ADDENDUM 3

Contract: 26-C-00038; Pump Station Resiliency and Reliability Improvements (A)

Item 1 – Plan modifications are described below for the respective pump stations. Additional attachments are the revised plan sheets.

No.	DATE	REVISIONS	No.	DATE	REVISIONS	DES: ST	ATLAS	CITY of TAMPA Mobility Department Stormwater Engineering Division	CURIOSITY CREEK SINGLE LINE DIAGRAM (DEMOLITION)	SHEET E3 OF 27
1	10/09/2026	REVISED FOR ADDENDUM	4			DRN: SRP				
2			5			CKD: MJC				
3			6			DATE: 4/27/26

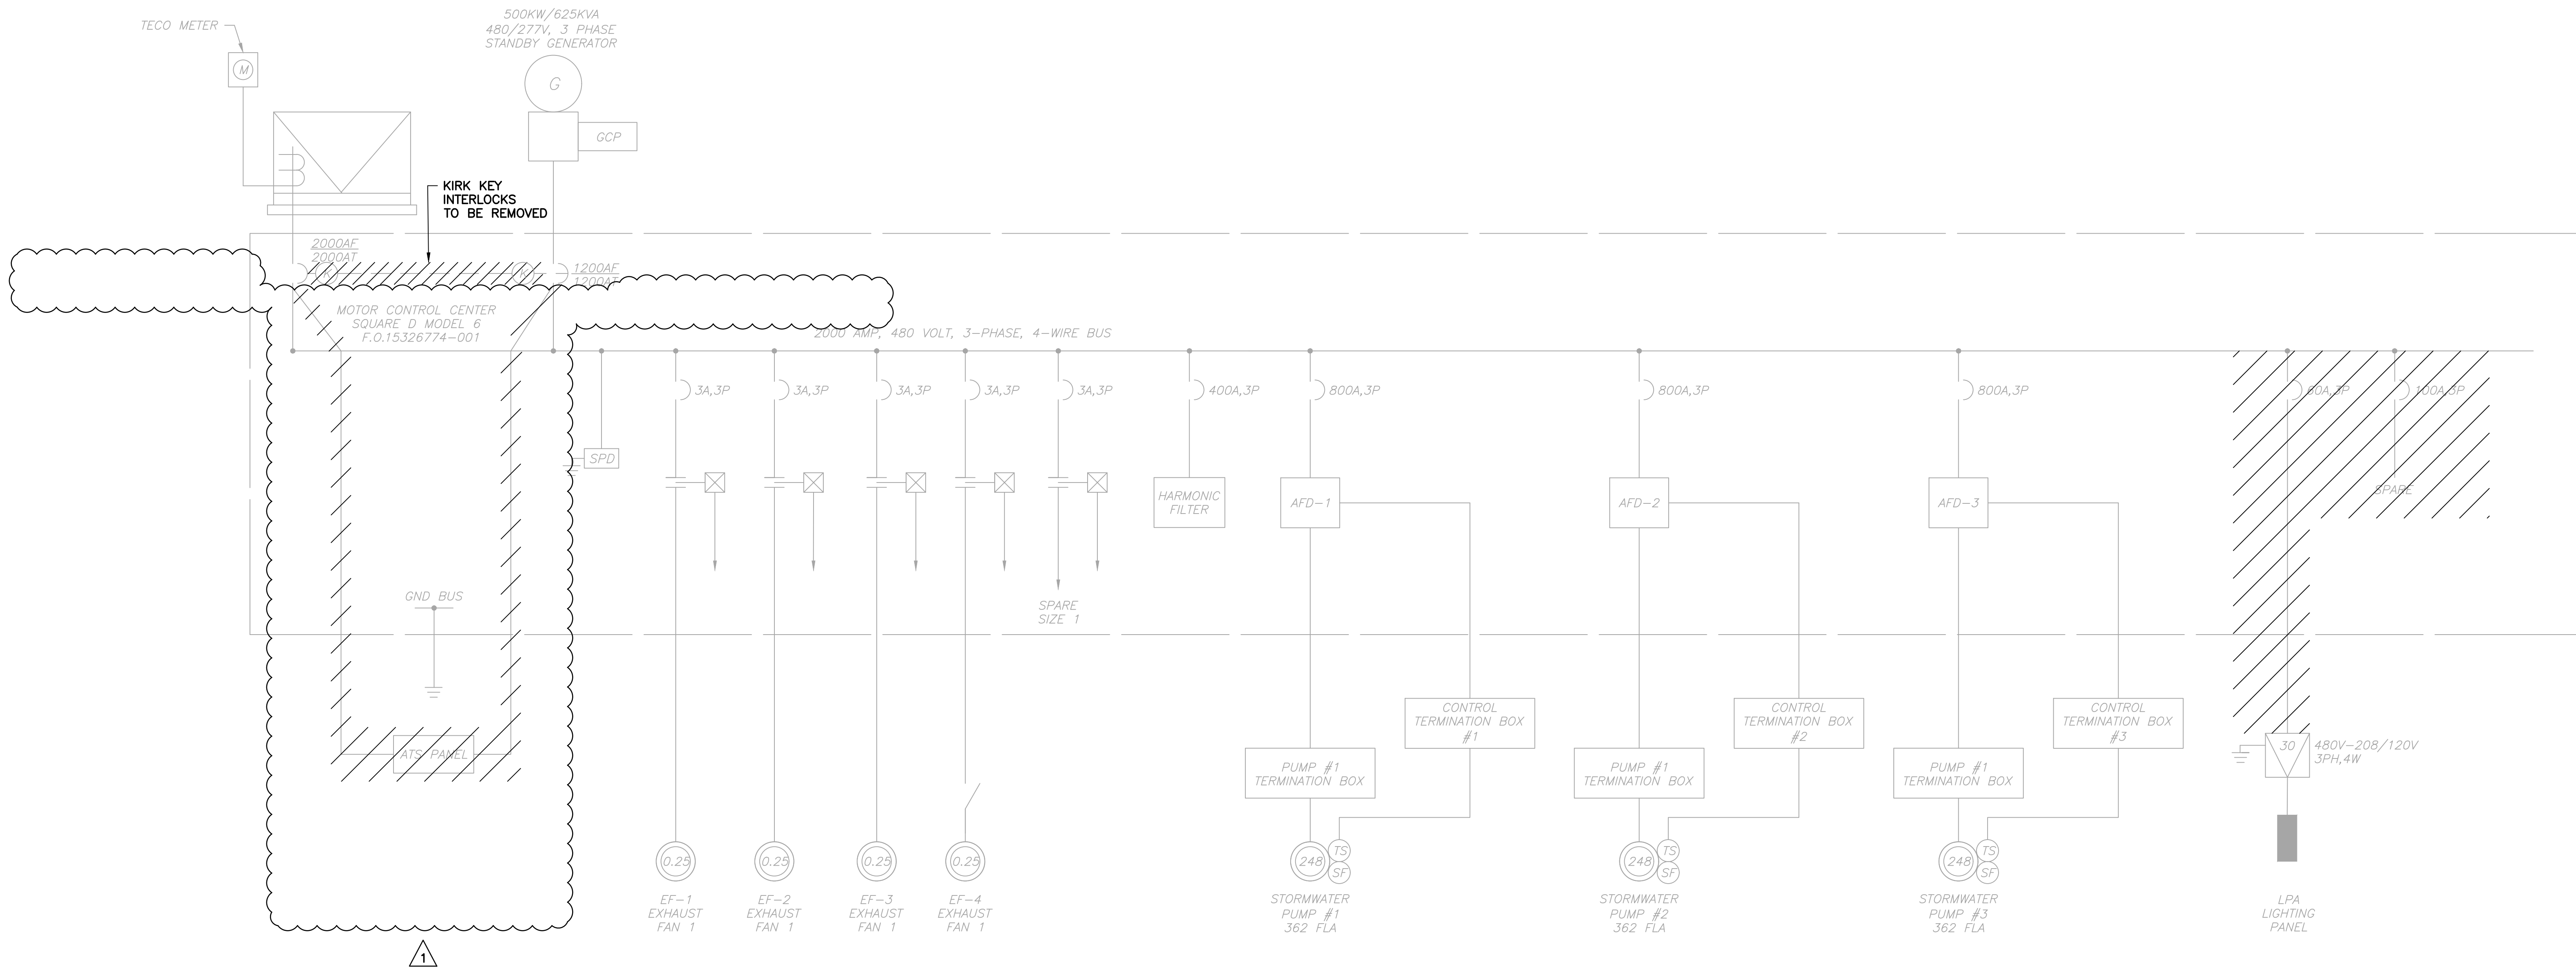
Remove all work associated with the new automatic transfer switch and associated power conductors and conduits. The existing onsite automatic transfer controller will be removed and replaced with a new automatic throwover (ATO control panel). New control wiring will be provided. The PC panel will be removed and replaced with a PC/TC lighting panel as shown. The following drawings and specifications are revised:

- Clouded revisions on the following sheets: E3, E4, E7, E8, E10, E11, and I2
- A new specification: 26 36 24 – Automatic Throwover Controls
- Removal of the existing specification: 26 36 23 – Automatic Transfer Switches

CURIOSITY LEVEL ELEMENT INSTALLATION

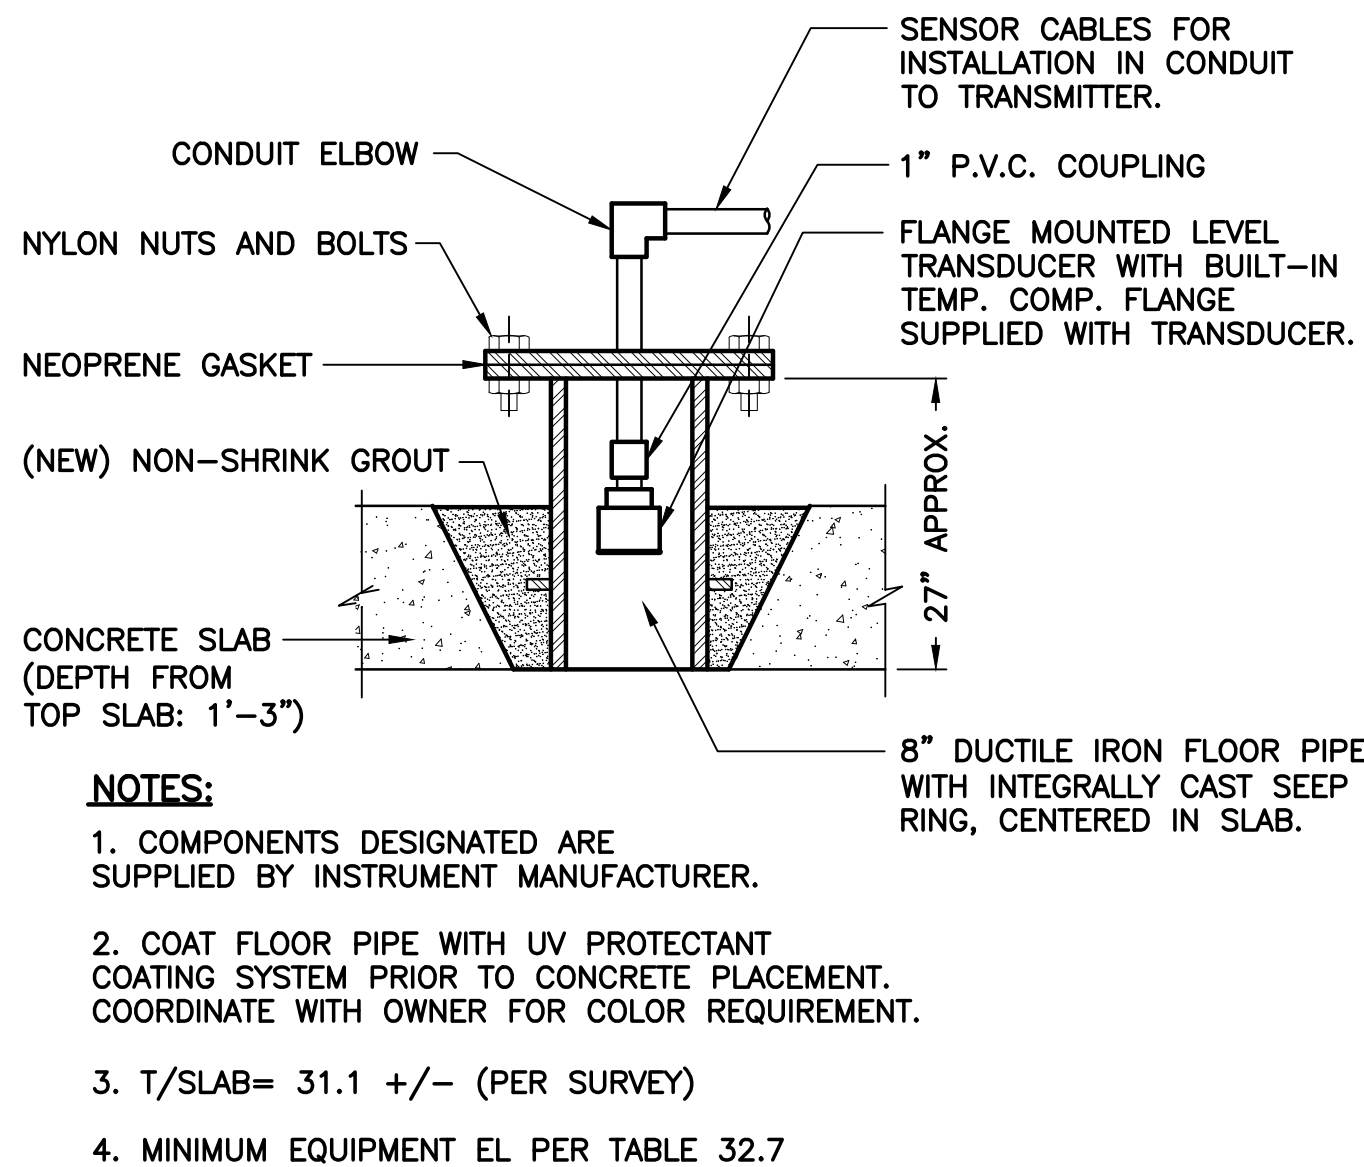
The level element installation detail has been revised, refer to Drawing E8.
